**RE: Request for Further Information of Amberfield Development,
Peacockes Road, Hamilton**
(Our Reference: 14280.000.000_21)

ENGEO Ltd was requested by Weston Lea Limited to prepare a response to the Request for Further Information letter received from Hamilton City Council dated 5 July 2018. We have been asked to respond to particular questions (as detailed below) and understand that the remaining queries will be answered by other members of the consulting team.

SCALE 1:800

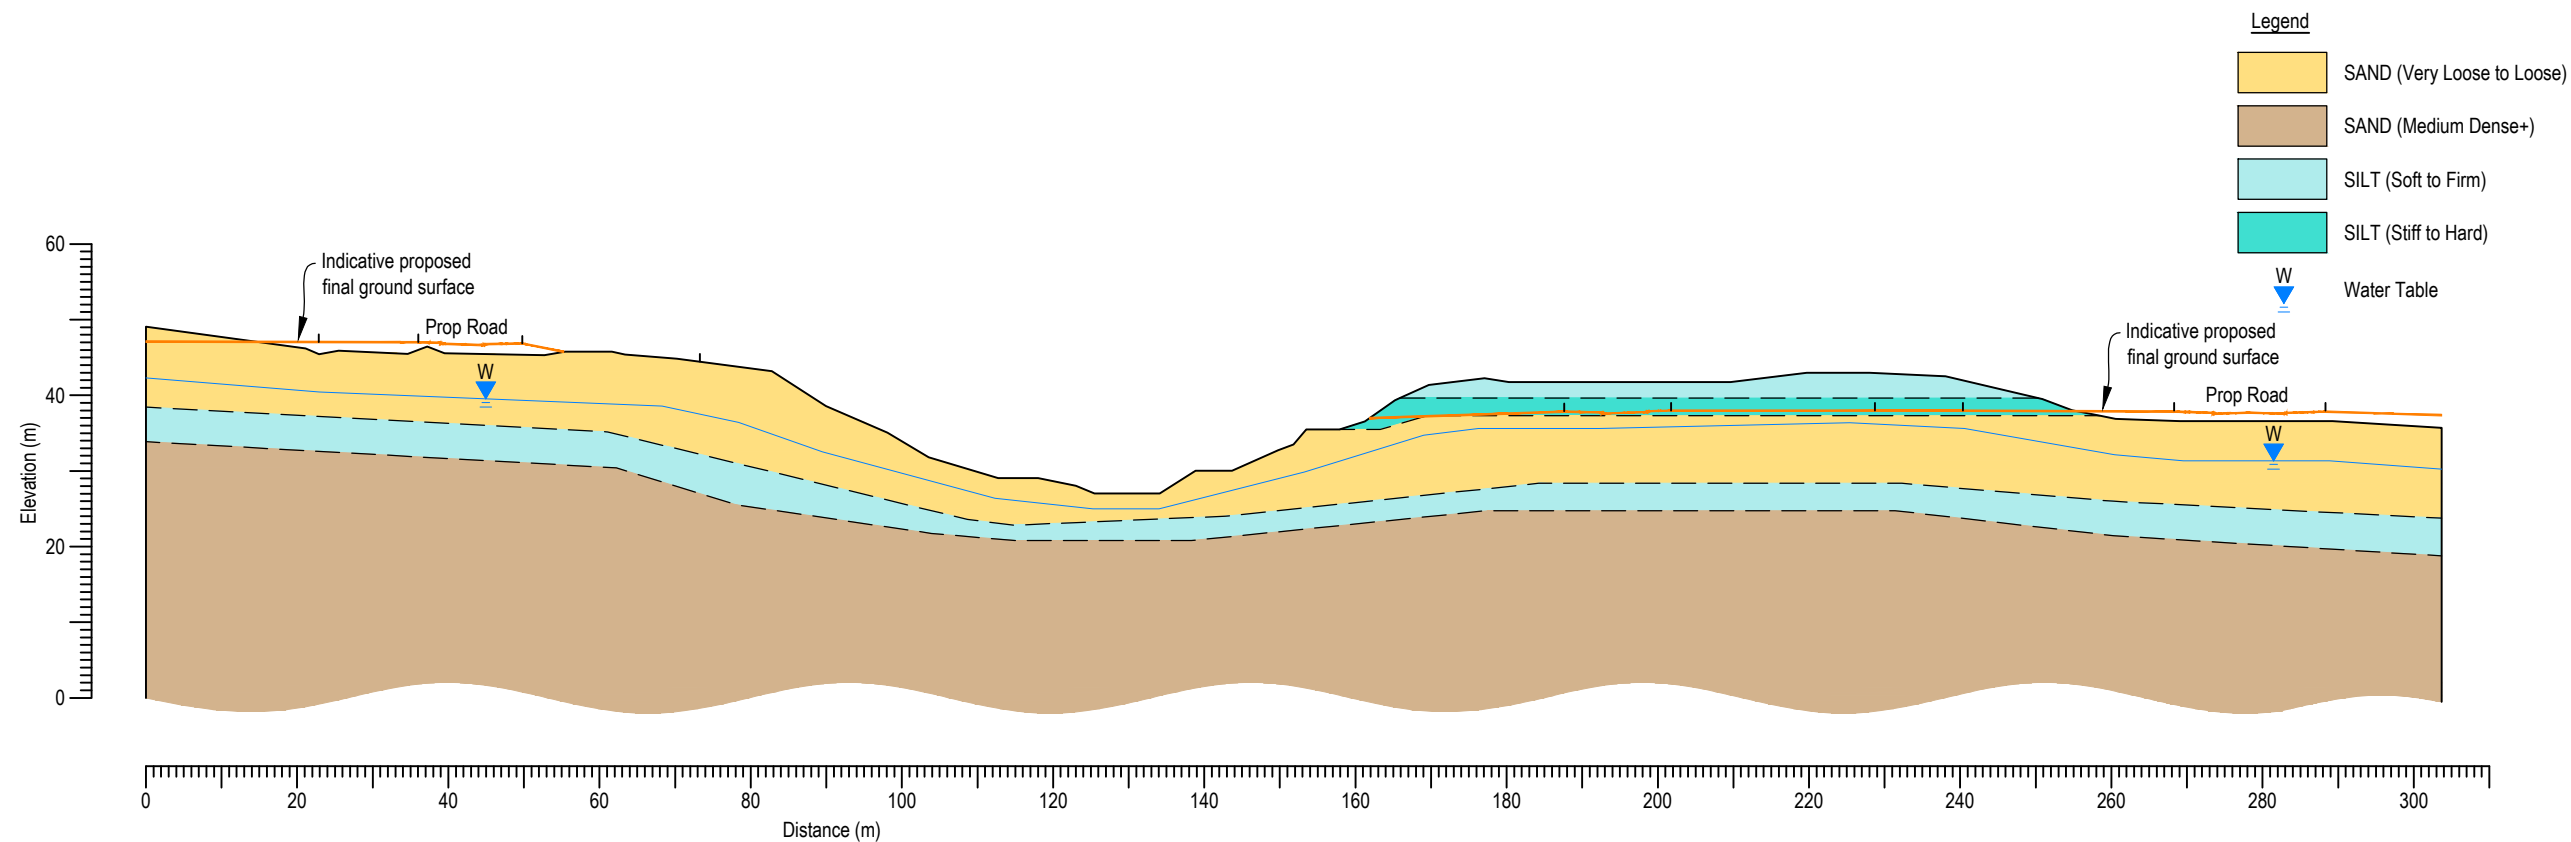
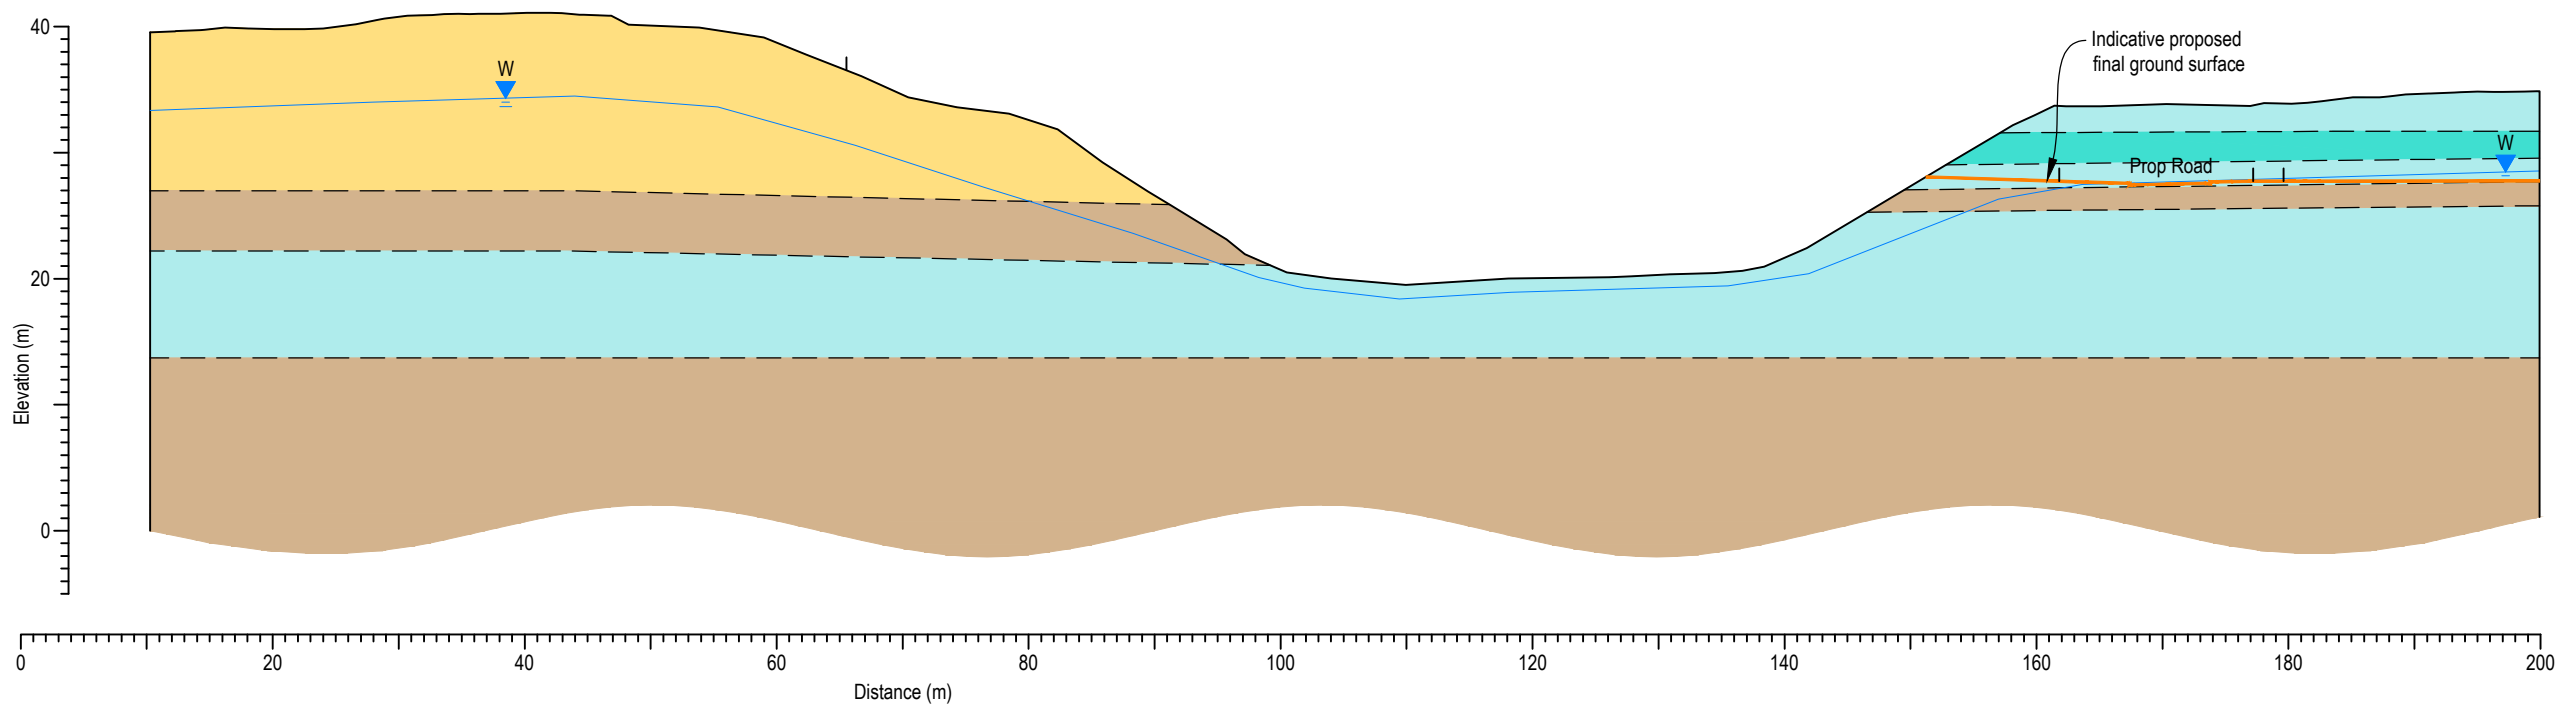
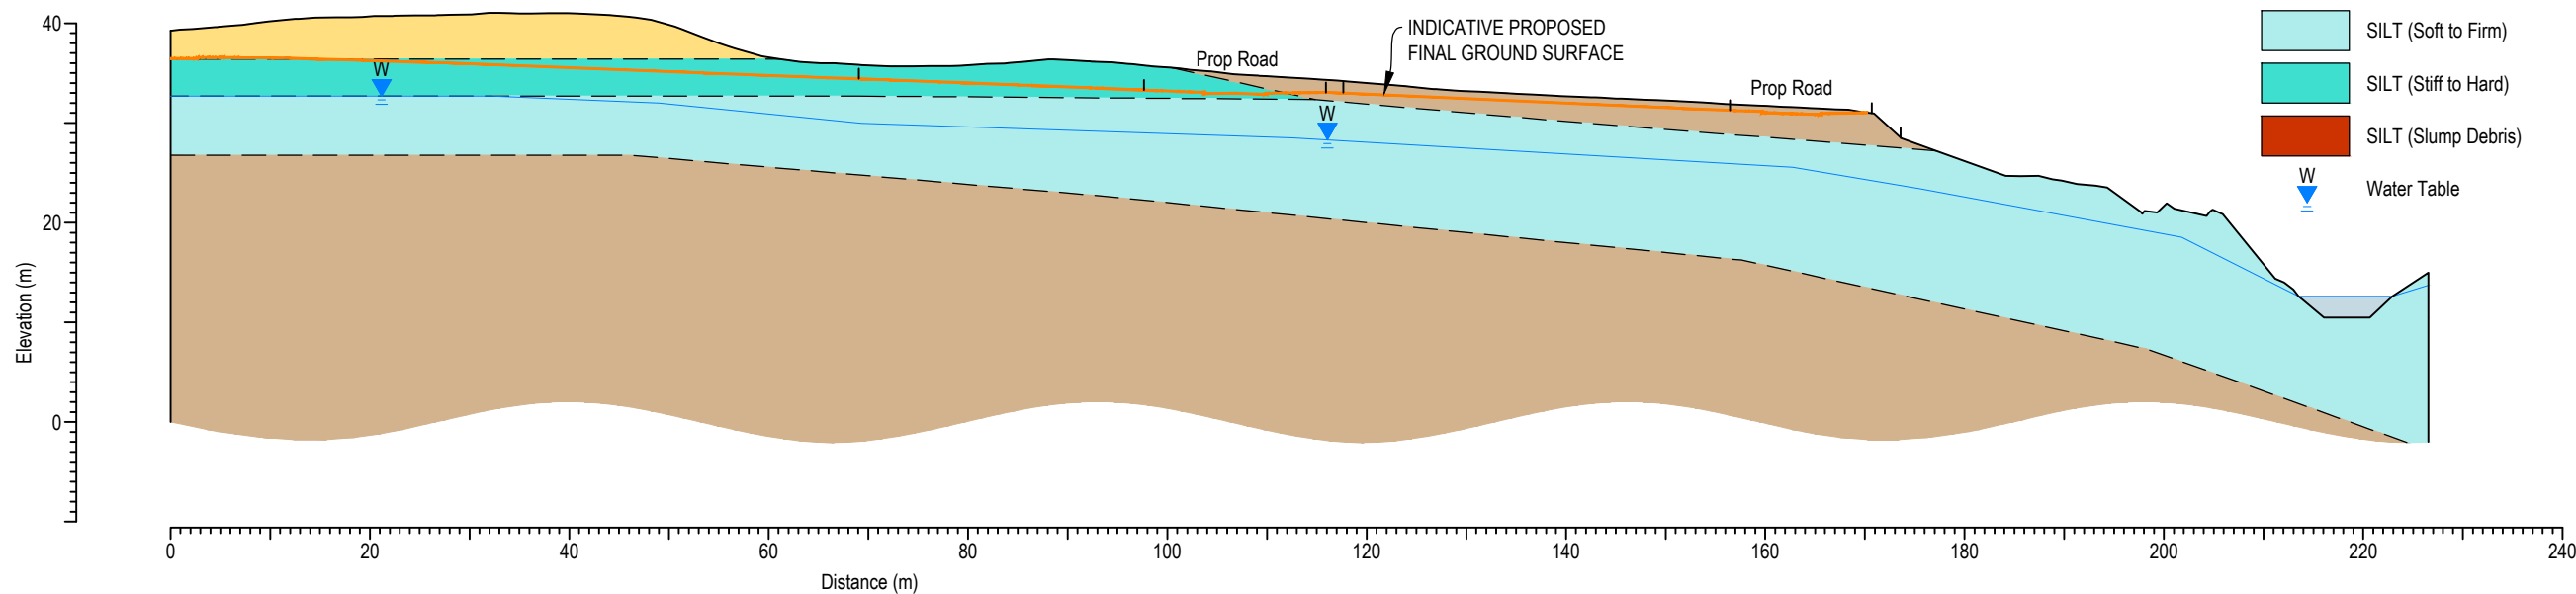
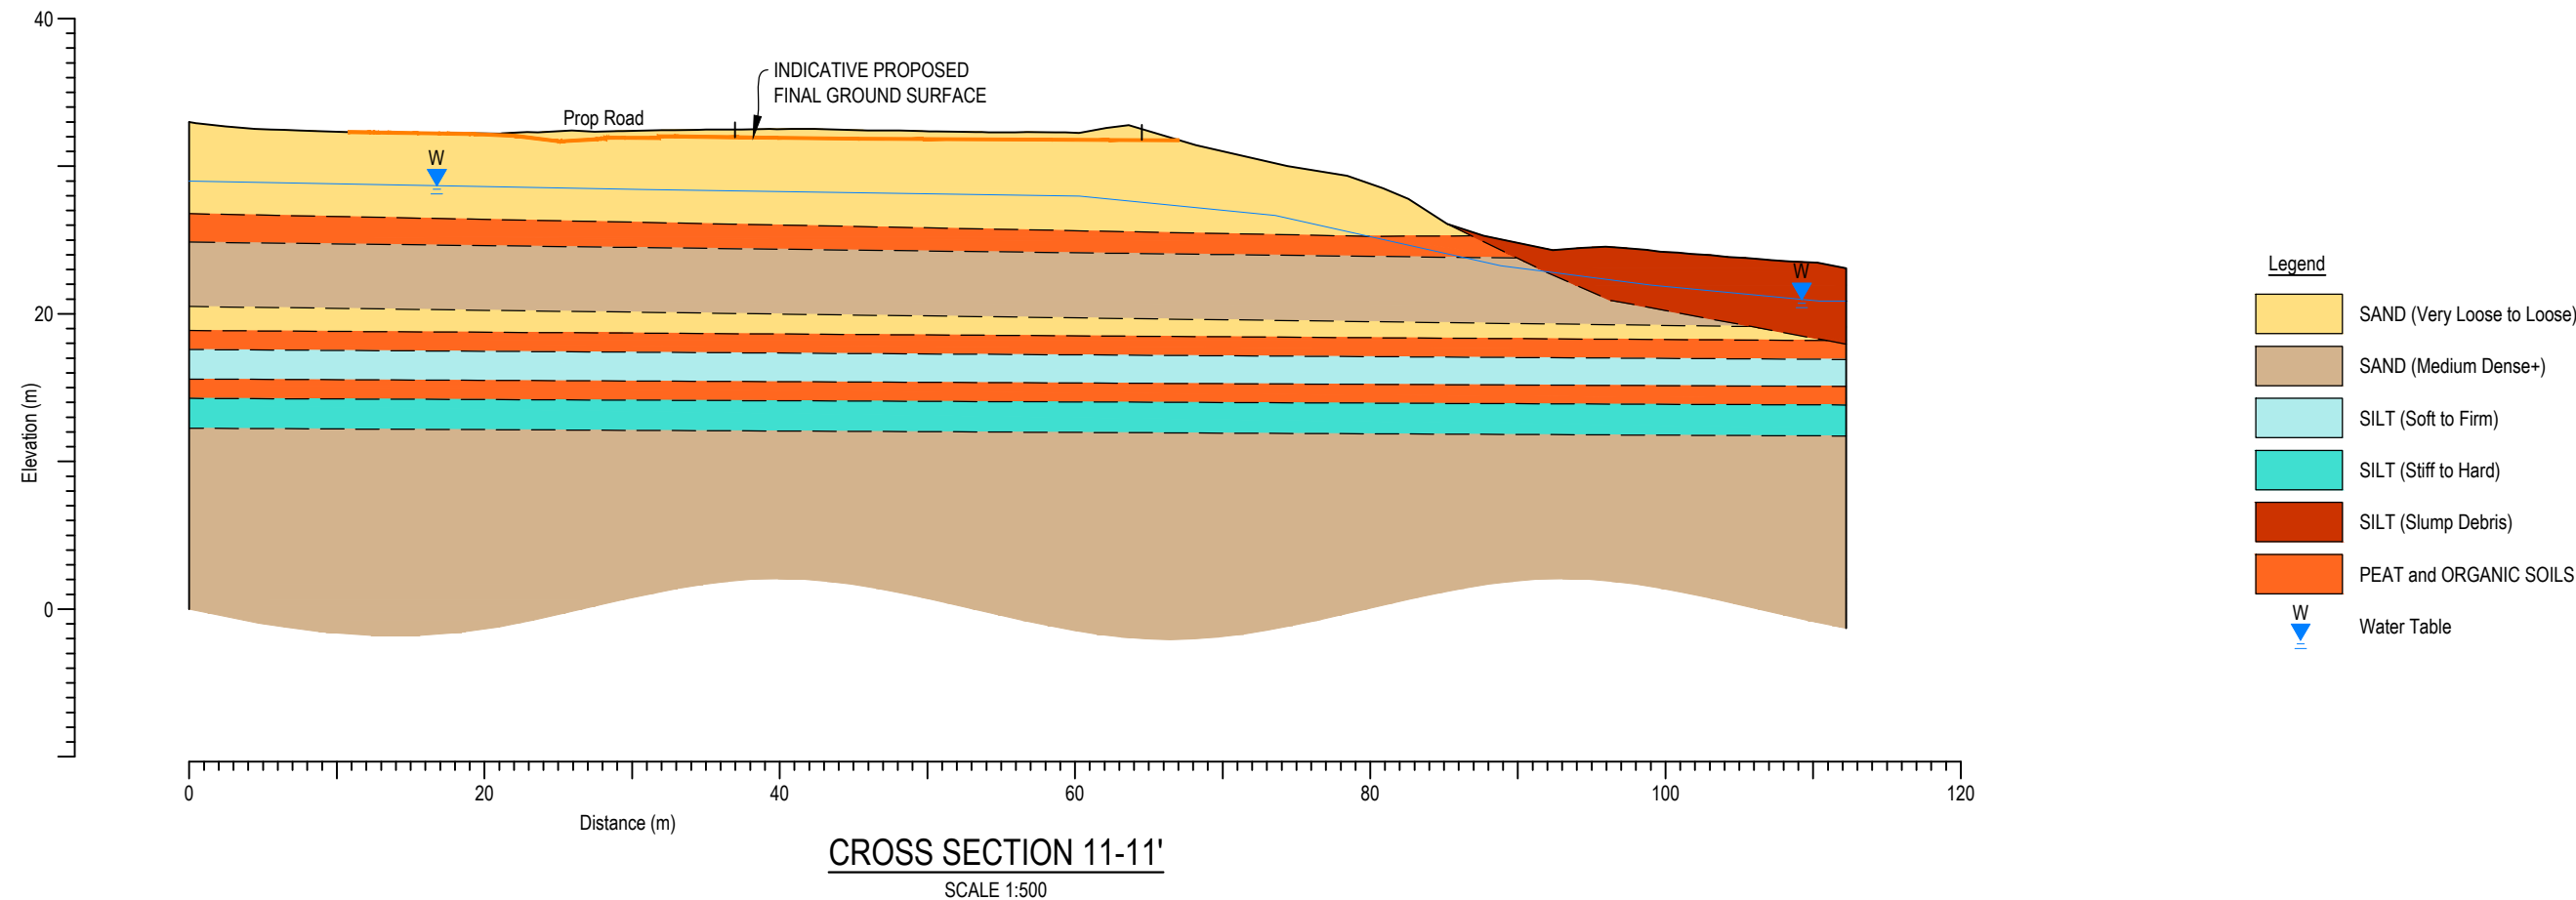
36. *The slope stability assessments appear to use the soil models given in the geological sections in Appendix 8 of the Interim Geotechnical Investigation Report. These cannot be reviewed effectively without the borehole information superimposed. The assessment makes an assumption that the hard layer encountered at the base of the CPT investigations is continuous with depth (Section 13.1). It is not possible to review this claim as the data has not been provided and it is not clear what the geological unit is. The geological units in question are highly variable so the assumption that this layer is continuous with depth is not necessarily sound and should be justified. Please provide substantiation for assumptions made in the geological model.*

Please find updated geological sections attached.
